REMARKS

Enclosures: Proposed corrections to Figs. 1 and 2

FIG. 1

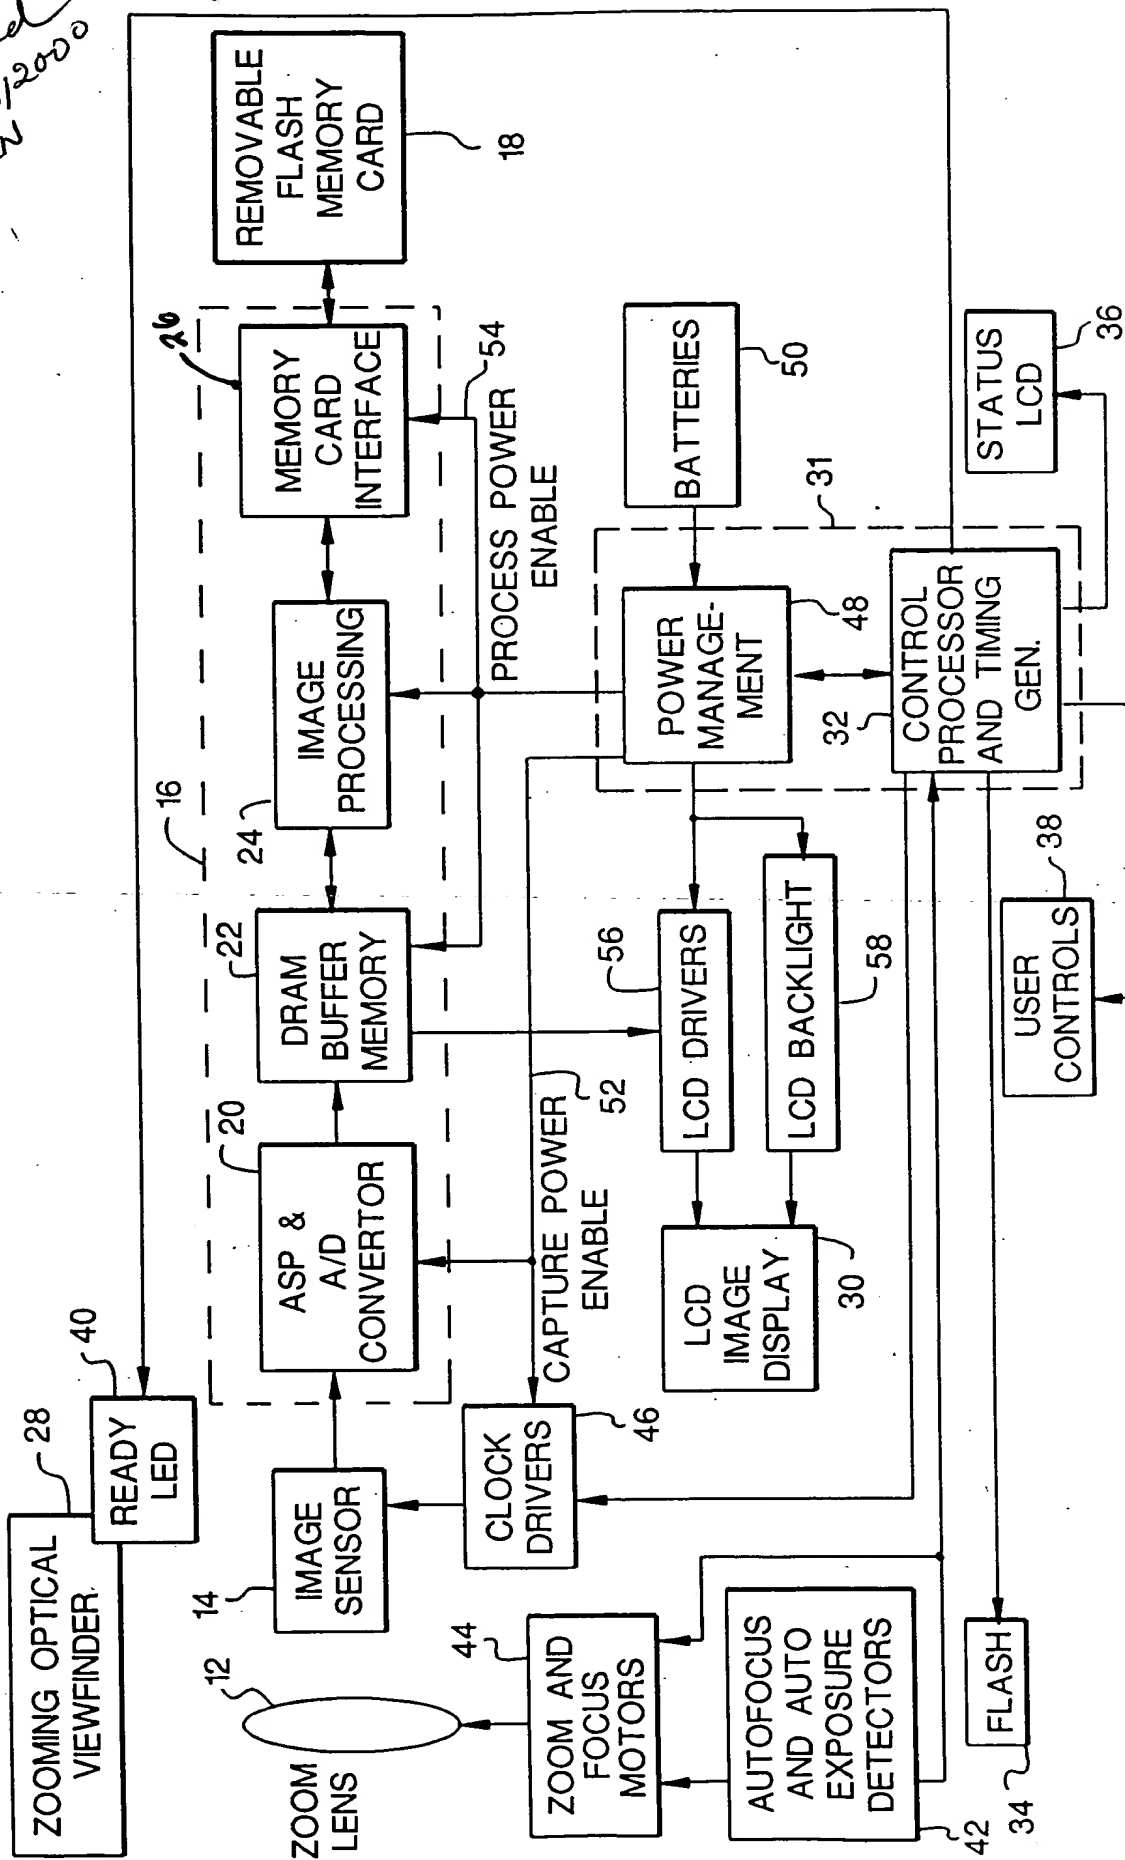
The drawings were objected to under 37 CFR 1.84(p)(5) because they fail to show element 26 in FIG. 1 and element 50 in FIG. 2C as described in the specification.

Subject to approval of the Examiner, the enclosed FIGS. 1 and 2C have been corrected so that elements 26 and 50 properly designate the corresponding parts. Accordingly, these changes should remove the Examiner's objections to FIGS. 1 and 2C. Applicants will submit corrected formal drawings upon an indication of allowable subject matter.
